Access Compliance Report

Public Rights-of-Way

(Curb Ramps)

Intersection ID: 50539	Main Street: CAYENNE_DR	Cross Street: MT_HOLLY-HUNTERSVILLE_RD	Location: SW
ADA ID: D8DD7A27B989	Ramp Type: Perp	Initial Pass/Fail: Fail	Overall Compliance: No
Severity Score: 33.75			
Codes/Mitigation Info/Possible Solution		Field Measurements/Component Compliance

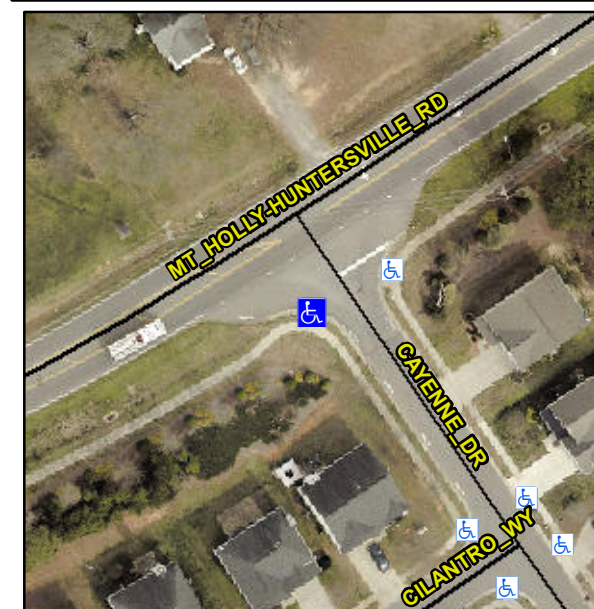
Not Found, R304.5.1, R304.5.3

Compliance	Description	Data	Compliance	Description	Data
N/A	Ramp Length (in)	48.5	Yes	Ramp Slope (%)	5.9
No	Ramp Width (in)	46.0	No	Ramp XSlope (%)	8.4
N/A	Flare Type LT	N/A	N/A	Flare Type RT	N/A
N/A	Flare Slope LT (%)	N/A	N/A	Flare Slope RT (%)	N/A
N/A	Flare Traversable LT?	N/A	N/A	Flare Traversable RT?	N/A
N/A	Landing Length (in)	N/A	N/A	DWS Provided?	N/A
N/A	Landing Width (in)	N/A	N/A	DWS Contrast?	N/A
N/A	Landing Slope (%)	N/A	N/A	DWS Length (in)	N/A
N/A	Landing X Slope (%)	N/A	N/A	DWS Full Width?	N/A
N/A	Landing Curb? (Y/N)	N/A	N/A	DWS Offset (in)	N/A
N/A	Shared Landing?	N/A			
N/A	Gutter Ponding?	N/A	N/A	Gutter Slope (%)	N/A
N/A	Gutter Lip Ht (in)	N/A	N/A	Gutter X Slope (%)	N/A
N/A	Painted X Walk1?	No	N/A	Painted X Walk2?	N/A
	X Walk 1 Direction	To E		X Walk 2 Direction	N/A
N/A	X Walk 1 Width (in)	N/A	N/A	X Walk 2 Width (in)	N/A
	X Walk 1 Slope (%)	3.5		X Walk 2 Slope (%)	N/A
	X Walk 1 X Slope (%)	5.5		X Walk 2 X Slope (%)	N/A

Remove & Replace Entire Ramp.
